Meeting Agenda - Final-revised Planning and Zoning Commission

Wednesday, April 28, 2021

Preliminary Approval of Subdivision #21-01 - Alaska State Land Survey No. 2009-10. A Municipal Entitlement Selection - Mineral Creek Islands - ADL 201084.

File: **ASLS No. 2009-10**
Subj: Survey Instructions
ADL No. 201084

PRELIMINARY SUBMITTAL APRIL 14, 2021

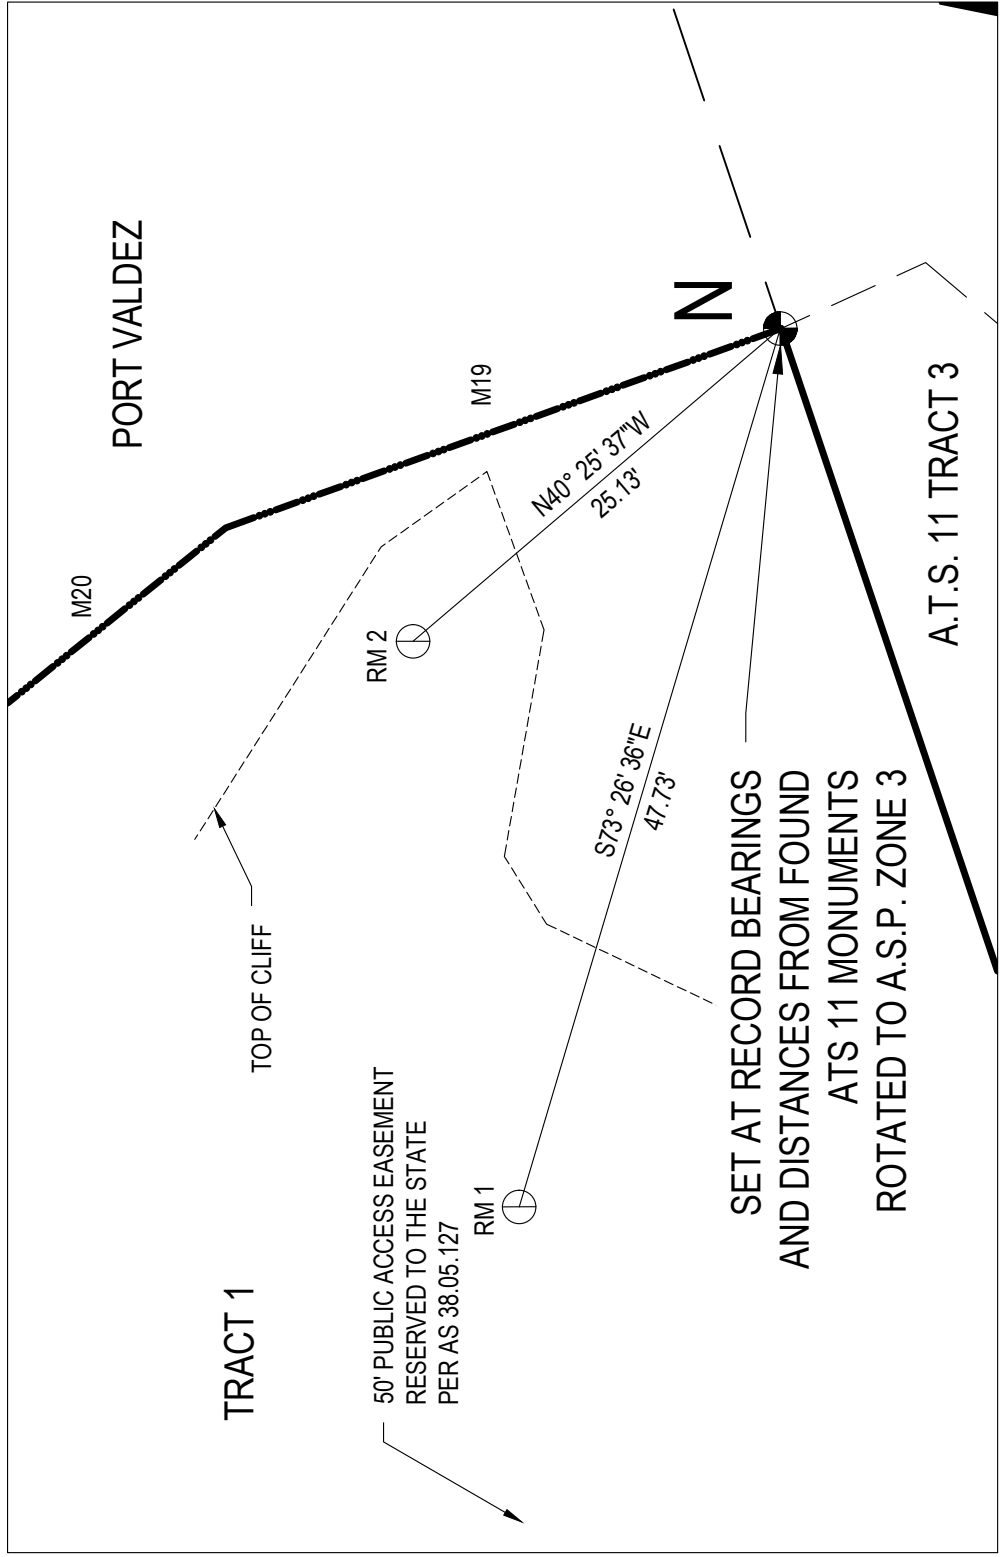
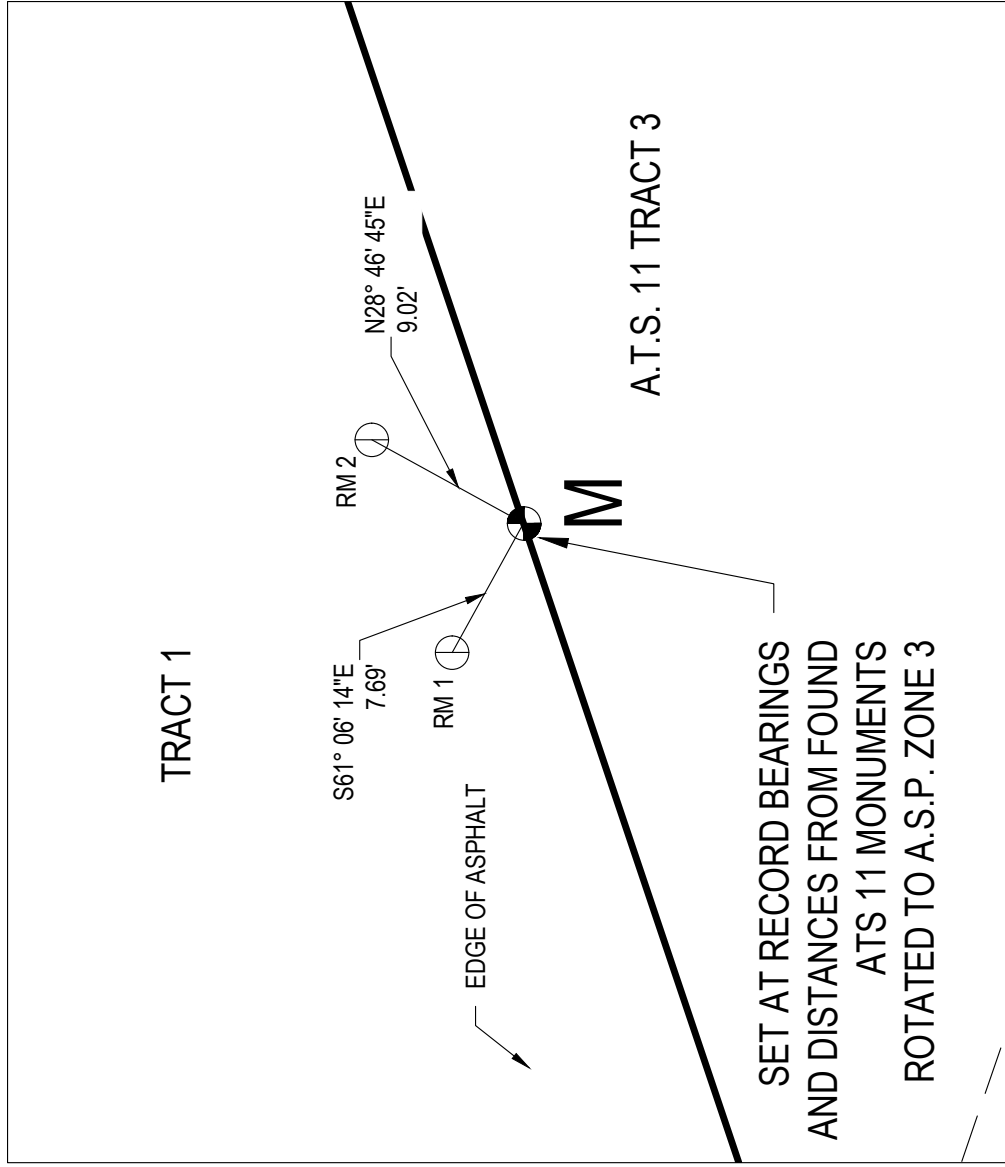
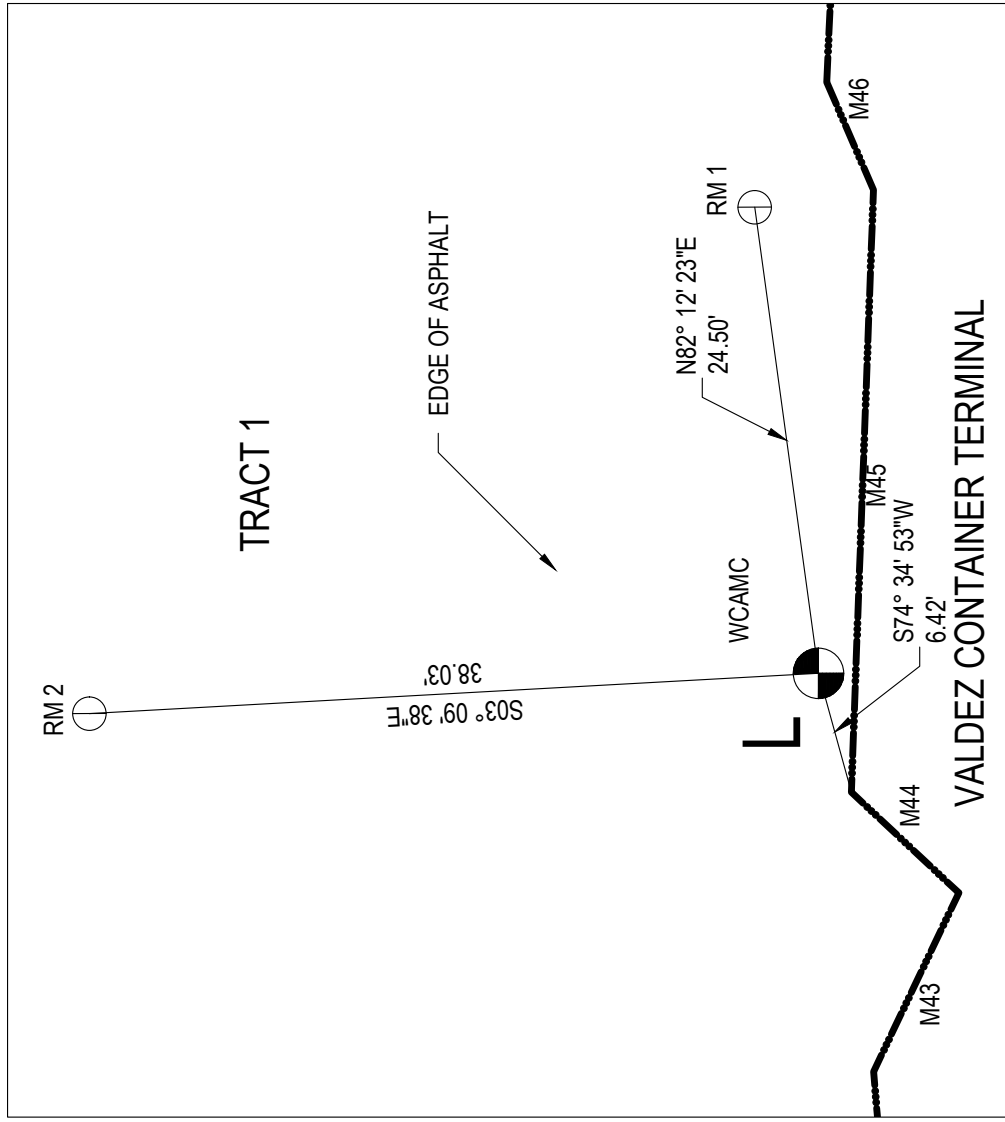
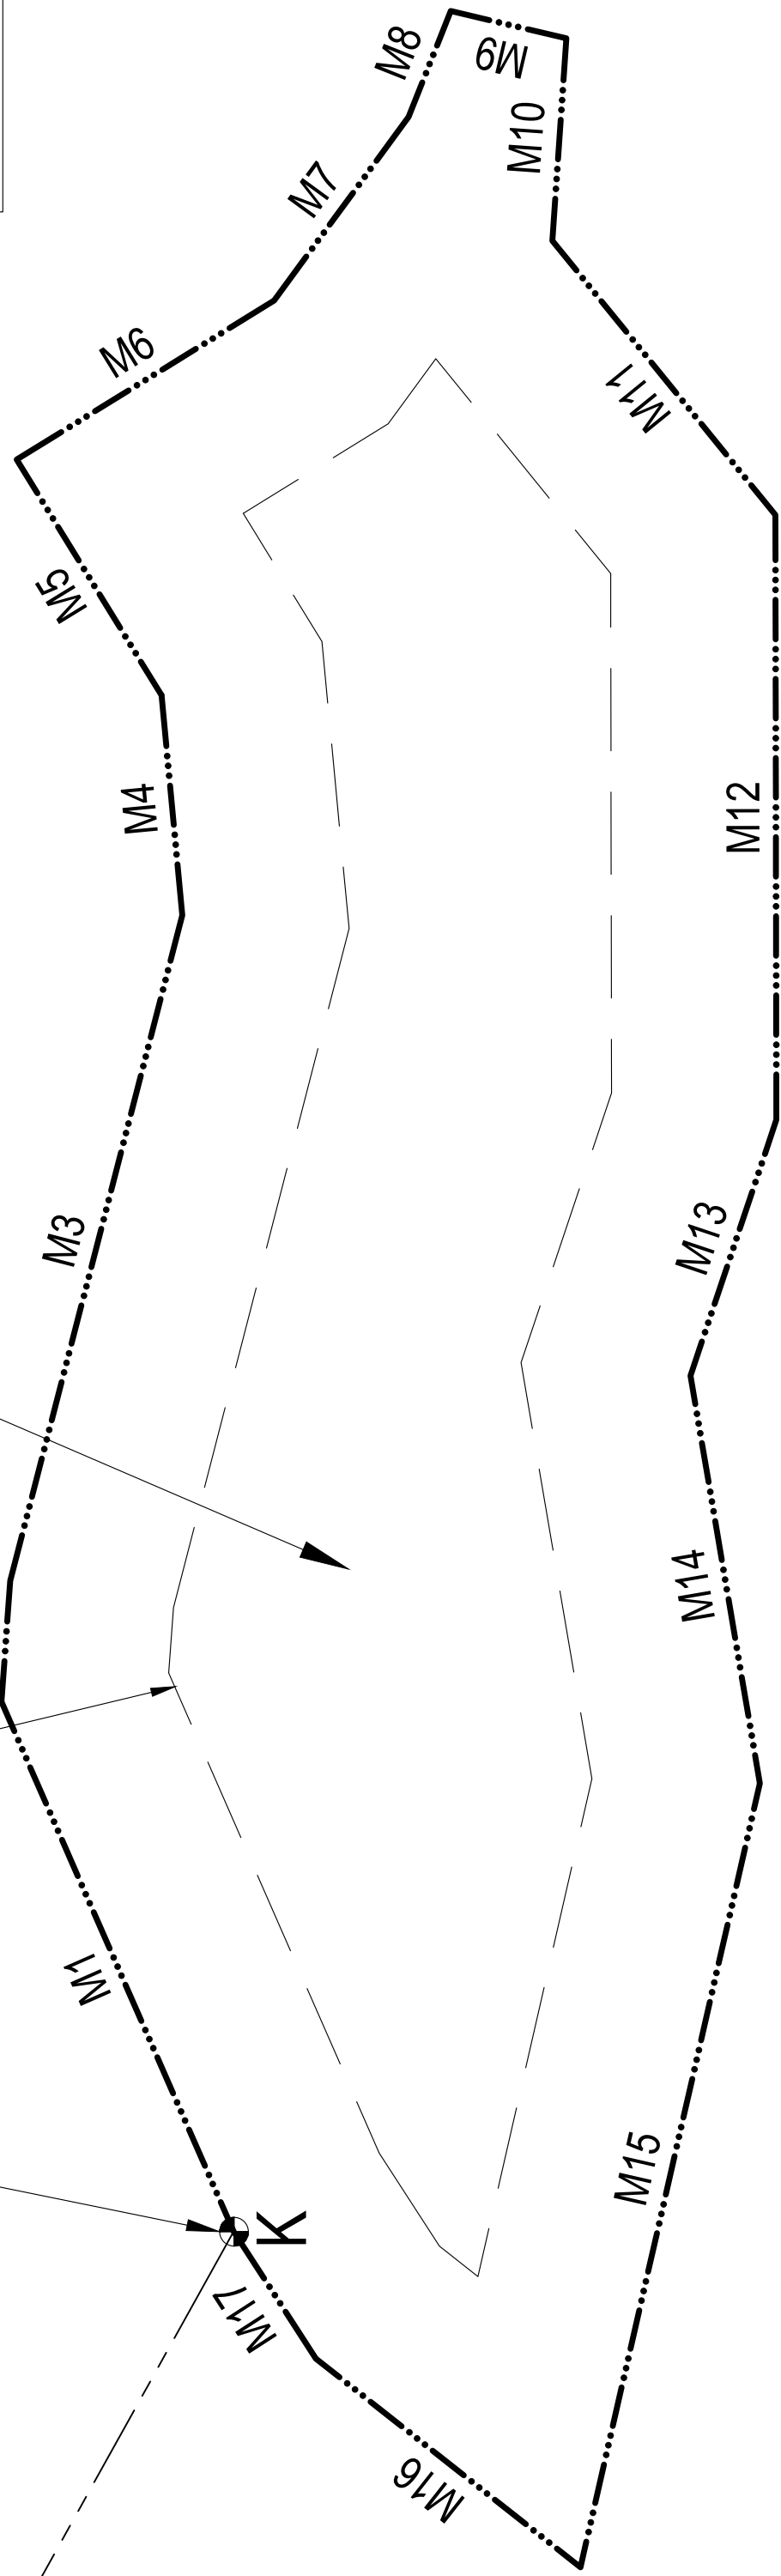
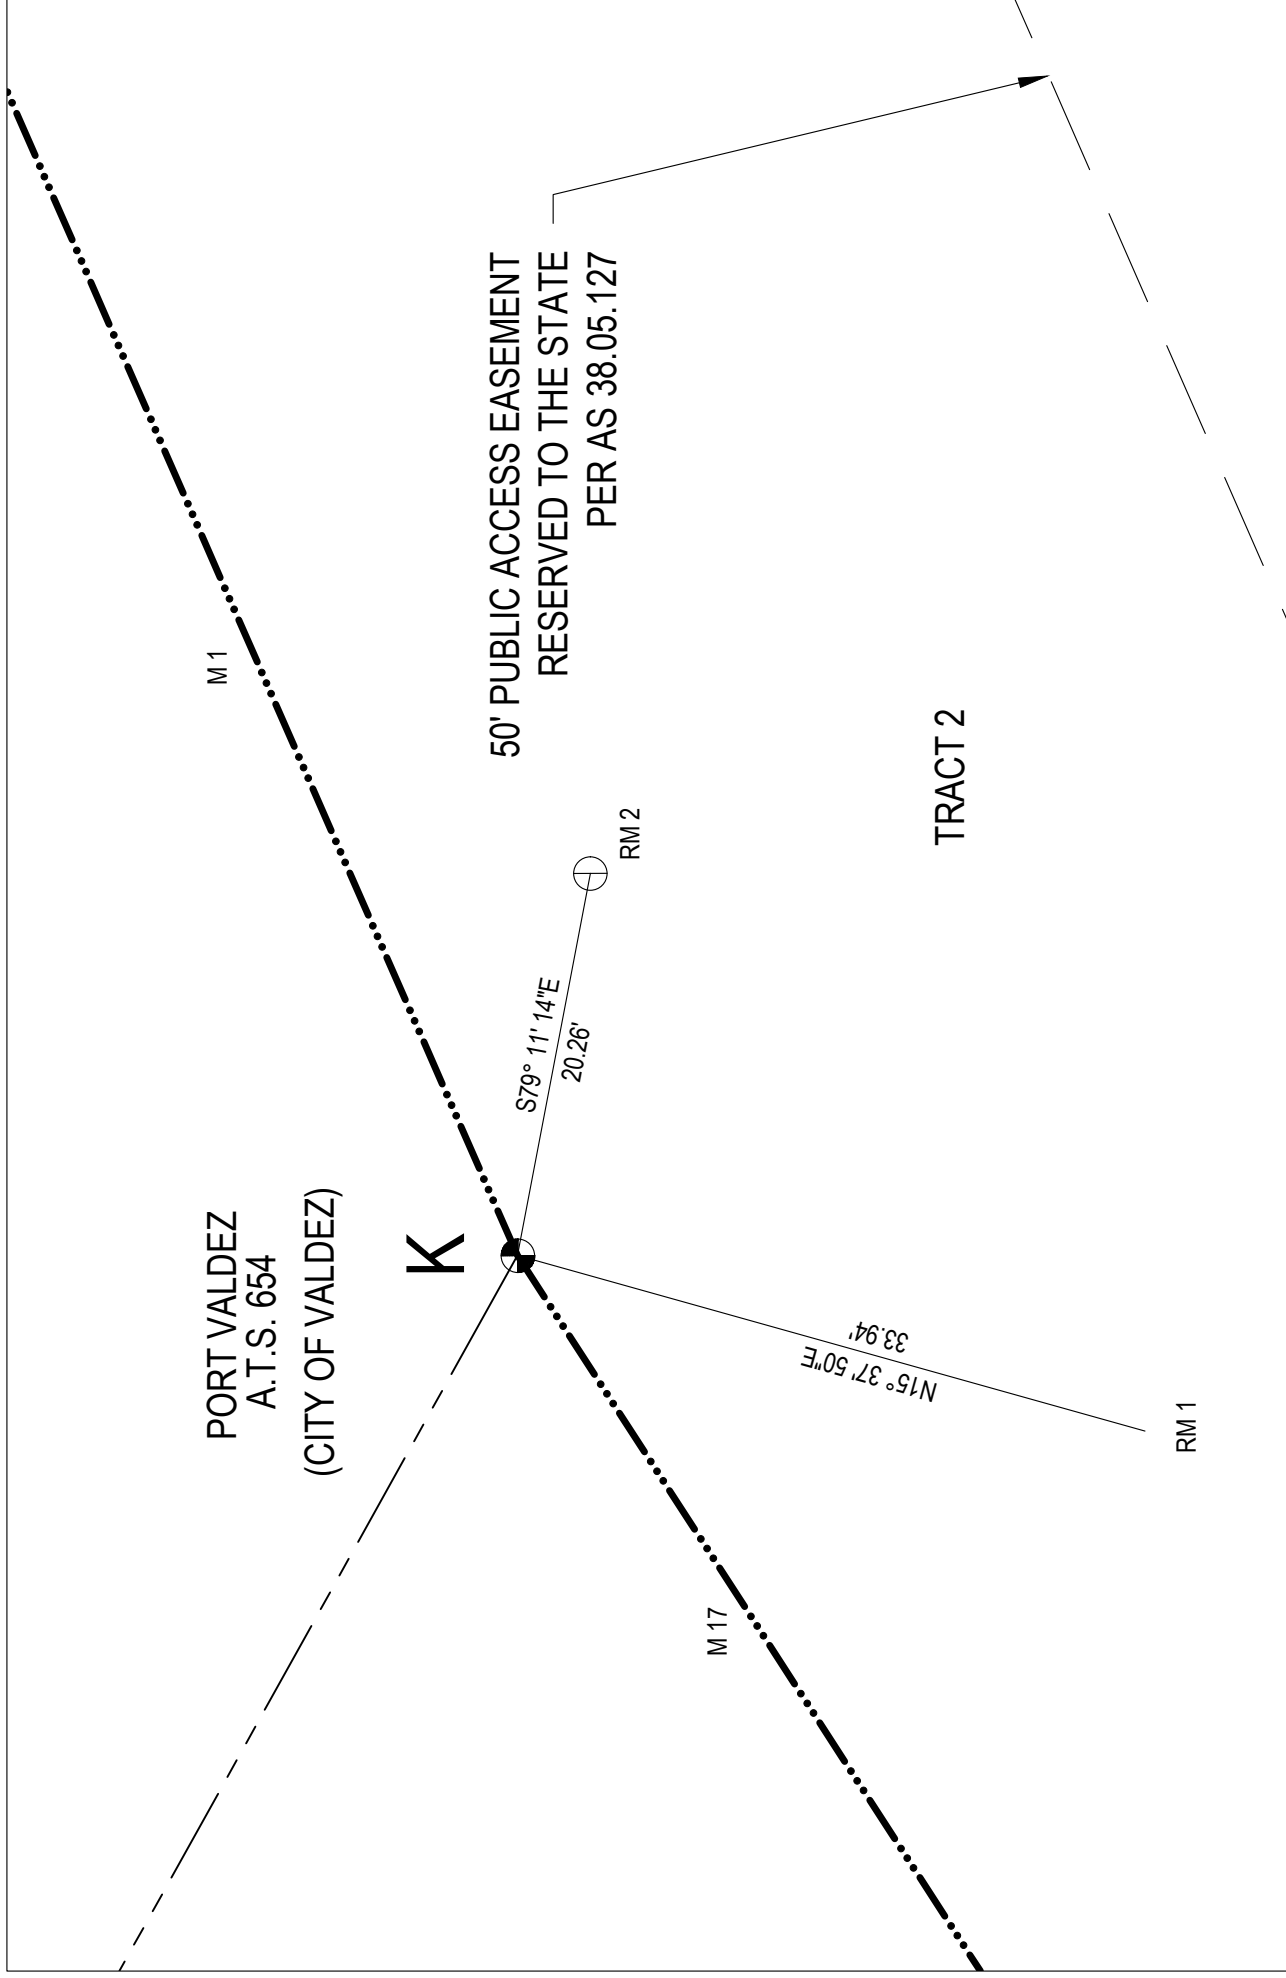
- a. The Survey Instructions (SI) indicates that the fixed and limiting boundary of Tract 1 should be as close to the pre-fill mean high water line as possible. Since the City of Valdez received patent for the tidelands surrounding Tract 1, we want to avoid issuing patent for uplands that were previously conveyed as tidelands.
- b. Provide a copy of the 1985 VEI Plat that was the source of the pre fill meanders.
- c. Show ATS 11 Tract 2 and Tract 3, exclude Tract 2, ATS 11 from the Tract 1, ASLS 2009-10.
- d. How were Mons C & D reestablished?
- e. Clearly show the relationship of Tract 1, ASLS 2009-10 to Tract 2, ATS 11.
- f. Identify boundaries fixed by fill as "fixed and limiting"; for clarity, a unique line type may be used.

- g. Depict and label the current mean high water line for Tract 1 along the northern boundary that is unaffected by fill per the SI.
 - h. Depict and label the public access easement for Tract 1 along the northern boundary that is unaffected by fill per the Plan of Survey

2. Regarding the Basis of Bearing:
 - a. If USS 4600 is the intended record plat, note the date the plat was accepted by the BLM.
 - b. Verify the markings on USS 4600 Lot 2 C4/Lot 1 C5. USS 4600 field notes refer to the parcels as "lots" not "tracts"; when were the lots renamed? According to the field notes of USS 4600, the monument was not marked "WCMC2". Was the original USS 4600 BLM monument recovered or has it been replaced and apparently mismarked?

3. For Monument A, AMC for Tract 2, remove the "WC" from the cap markings per submitted photo or note the witness distance if there is one.
 4. Per "Plat Review Process", page 12 of the Survey Instructions, provide legible photos or rubbings of all recovered monuments, and calculations, including lot summary reports.

5. Show the parcels adjacent to Tract 1 that were depicted on the first plat submitted for review but have been deleted from this plat.
 6. Depict the location of the tidal benchmark 4240 L 1978 by adding a tie or show the benchmark's location in the vicinity map.

- a. The tidal datum information varies slightly from the published data for Station No. 9454240; please explain in more detail the source of your data.

- b. Truncate the latitude and longitude values to those published by NOAA for Valdez.
 7. On Tract 2 show the "50' public access easement", and label to read: "50' public access easement reserved to the State per A.S. 38.05.127".

8. Regarding the notes:
 - a. Note 2: correct "great" to "greater".
 - b. Delete Note No. 4.
 - c. Note 5: add "except where fill has been placed contiguous with the boundary of Tract 1" to the beginning of the note.

9. Remove the DNR Plat Approval Certificate, the City of Valdez is the platting authority.
 10. Add a note stating the geographic coordinates were derived from the OPUS report for static GPS observation on date using (type) GPS equipment, with the NAD83 coordinate transformed to NAD27 using XX software.

11. With regards to the Vicinity Map, cite the source map used.
12. In the Applicant Certificate, correct the ADL No. : "ADL No. 201084, Tract 1 & Tract 2".
13. Remove symbols from the legend that are not depicted in the graphics.
 - a. Remove "(see note 1)" from the primary monument set label.
 - b. Ensure all line types used are listed in the legend.
14. Ensure the margins are minimum ½" on three sides and 1½" on the binding side per the Recorder's Office.
15. With regards to the title block:
 - a. Adjust the acreage in the title block.
 - b. Initial the checked by block.

Please correct all other items as shown in red on the enclosed copy of the plat.
